HISTORIC AND DESIGN REVIEW COMMISSION

February 02, 2022

HDRC CASE NO: 2022-058
ADDRESS: 1930 W MISTLETOE
LEGAL DESCRIPTION: NCB 1964 BLK 2 LOT E 48.7 FT OF 13 & W 1.3 FT OF 14
ZONING: R-6
CITY COUNCIL DIST.: 7
DISTRICT: Monticello Park Historic District
APPLICANT: Dorothy Choice/Horizon View Realty Investments LLC
OWNER: Dorothy Choice/Horizon View Realty Investments LLC
TYPE OF WORK: Enclose carport, column replacement, exterior alterations
APPLICATION RECEIVED: January 14, 2022
60-DAY REVIEW: Not applicable due to City Council Emergency Orders
CASE MANAGER: Katie Totman
REQUEST:

1. Enclose the existing carport to create a garage.
2. Restore a side door opening on the east elevation of the house.
3. Replace the metal porch columns with wood columns.

Proposed Garage - Front View

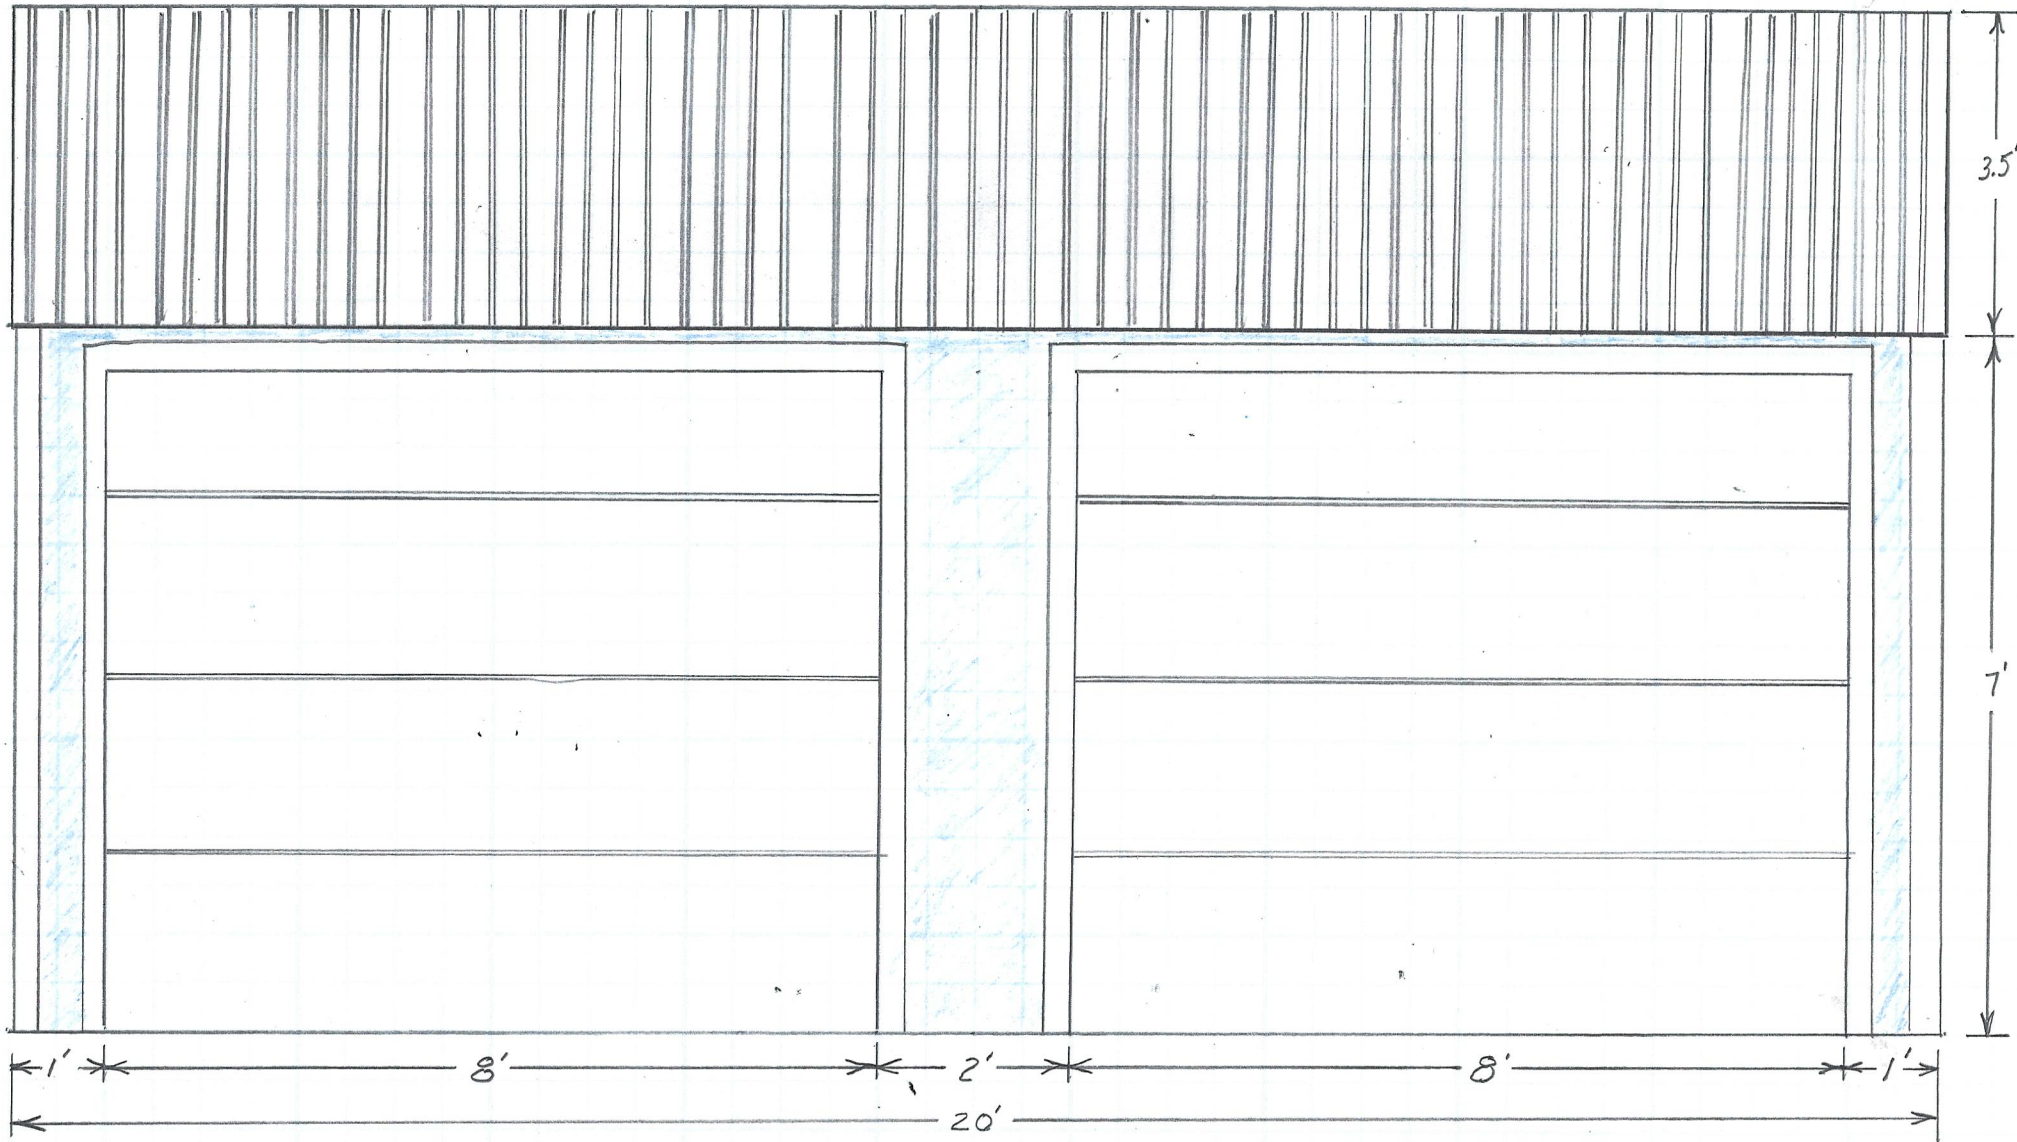
- b. CARPORT/GARAGE – The applicant has proposed to enclose the existing carport structure located at the rear of the property to create an enclosed garage. Siding will be added to the east and west elevations and garage doors will be added to the north elevation. Based on Sanborn Maps, an accessory structure appears on the property in the 1930s, though it is unclear whether the existing carport structure is original to the property. The overall footprint and roof form will not be modified. Per the Guidelines, when new materials are needed on outbuildings, they should match existing materials in color, durability, and texture. Ensure that garage doors are compatible with those found on historic garages in the district (e.g., wood paneled) as well as with the principal structure. Updates to rear structures should be based on the architectural style of the primary building and historic patterns in the district. Staff finds the proposal consistent with the Guidelines based on the modified nature of the carport, the compatibility of the enclosure design and materiality, and the double bay garage doors. Staff finds that the garage doors should be fully wood or feature a design that mimics wood construction and features a smooth finish without a faux wood grain texture.

- i. That the applicant installs a fully wood garage door or a garage door with a design that mimics wood construction and features a smooth finish without a faux wood grain texture. Final garage door specifications must be submitted to staff for review and approval prior to the issuance of a Certificate of Appropriateness.
- ii. That a column detail be submitted to staff for review and approval prior to the issuance of a Certificate of Appropriateness.

- iii. That the siding installed on the garage be wood lap, wood board and baton to match the existing siding, or be smooth finish hardi-lap siding to be consistent with the design guidelines.
